Los Angeles Regional Water Quality Control Board

REQUEST FOR RELOCATION OF RECEIVING GROUNDWATER MONITORING LOCATION IN WASTE DISCHARGE REQUIREMENTS (WDRs) AND NATIONAL POLLUTANT DISCHARGE ELIMINATION SYSTEM (NPDES) PERMIT FOR SANTA CLARITA VALLEY SANITATION DISTRICT (SCVSD), SAUGUS WATER RECLAMATION PLANT (SAUGUS WRP), (ORDER NO. R4-2022-0175, NPDES NO. CA0054313, CI NO. 2960)

Figure 1

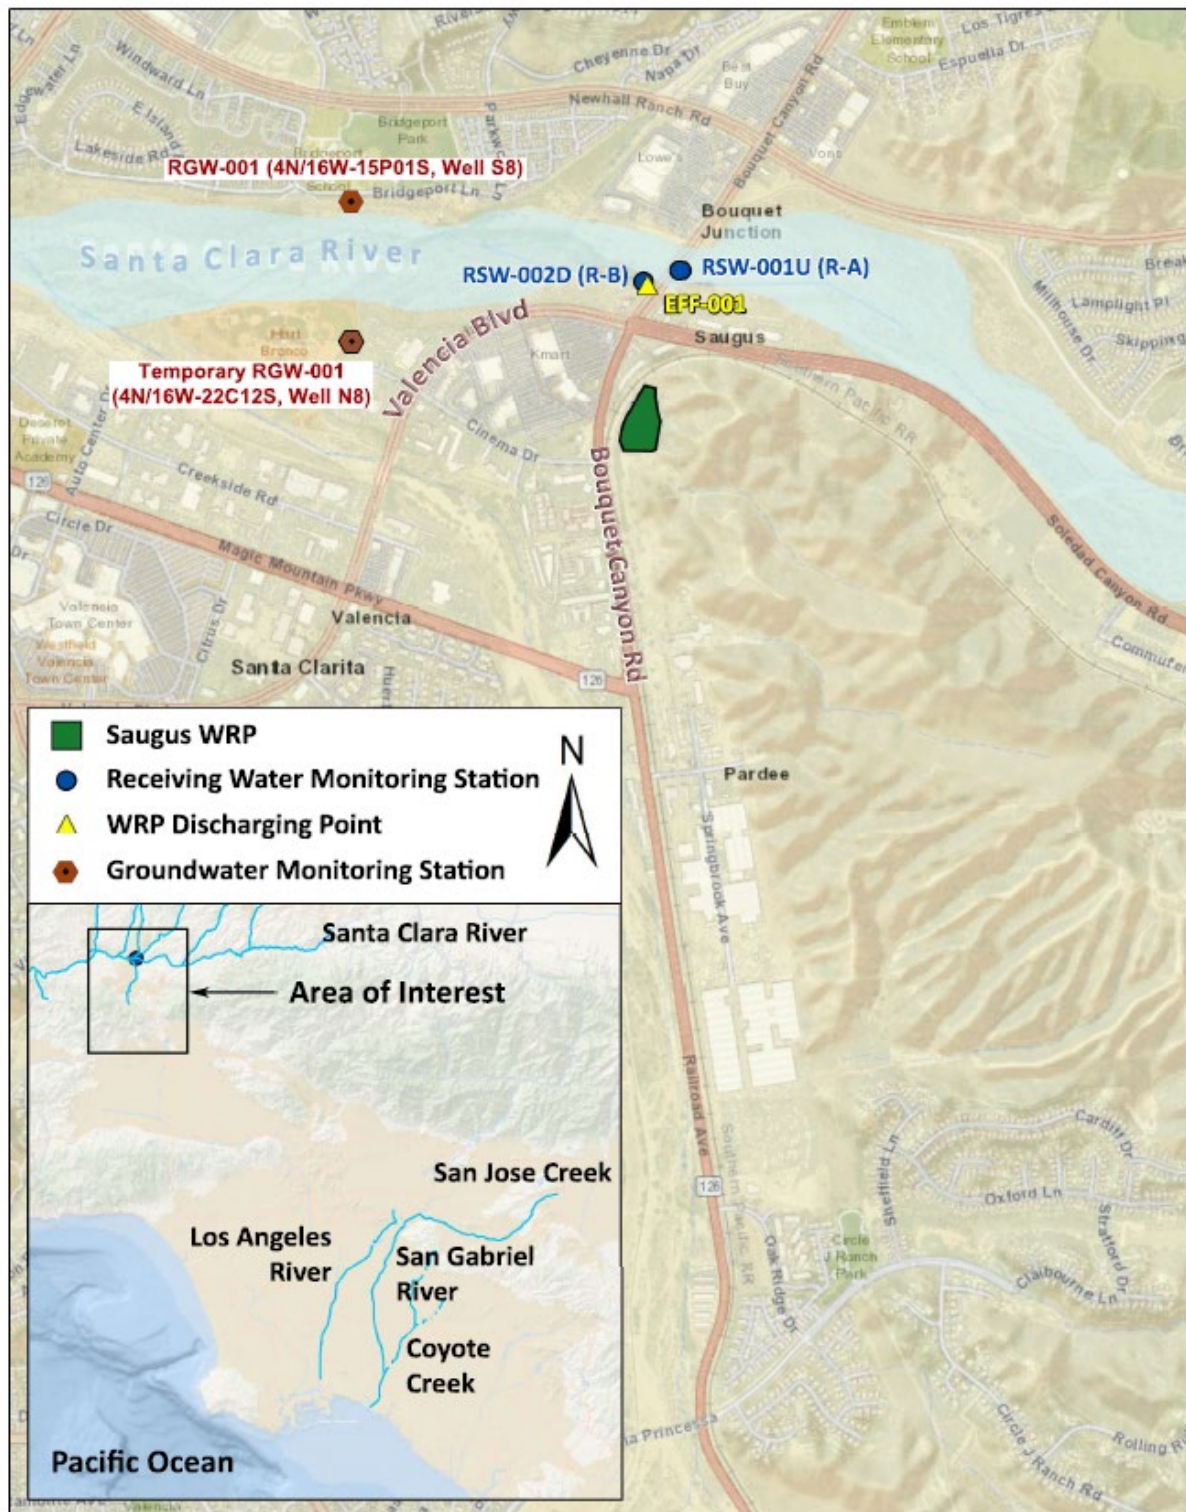
On August 12, 2025, the Los Angeles Regional Water Quality Control Board (Los Angeles Water Board) received a letter from SCVSD requesting relocation of the groundwater monitoring well in the Monitoring and Reporting Program (MRP) (CI-2960) contained in the Saugus WRP's NPDES permit (Attachment E to Order No. R4-2022-0175). On August 13, 2025, the Los Angeles Water Board staff requested that SCVSD submit similar information for this request that was provided for a related request in 2020 for a different well, including a comparison of the current well and the proposed replacement well, depth to groundwater, screening interval depth, and chloride concentrations for the past eighteen years. On August 26, 2025, SCVSD submitted the requested information. Section 8.2 in the MRP for Order No. R4-2022-0175 requires semi-annual groundwater sampling at station RGW-001, defined as Well No. 4N/16W-15P01S (Well S8). In February 2025, Santa Clarita Valley (SCV) Water Agency, the owner and operator of the water wells in the vicinity, took Well S8 offline for repairs. SCVSD will not be able to collect samples as specified in the MRP of Order No. R4-2022-0175 because Well S8 will remain offline for eighteen to twenty-four months. SCVSD evaluated nearby wells depicted in Figure 1, and proposes to use State Well Number 04N/16W-22C12S (Well N8) as a temporary alternative to Well S8 and assign Well N7 (No. 04N/16W-22C01S) as the temporary backup well.

After reviewing your request and the well evaluation information, the Los Angeles Water Board approves your request to temporarily assign Well N8 (No. 4N/16W-22C12S) as the designated well for groundwater sampling at station RGW-001 and assign Well N7 (No. 04N/16W-22C01S) as the temporary backup well for groundwater sampling at station RGW-001 (only if Well N8 becomes unavailable prior to the rehabilitation of Well S8). Well N8 and Well N7 are adequate substitutes for Well S8 because they are

located in the same aquifer, shows similar physical attributes, and similar water quality trends. Once SCV Water Agency completes rehabilitating Well S8, SCVSD shall notify the Los Angeles Water Board that Well S8 is back online and that groundwater monitoring will resume at Well S8.
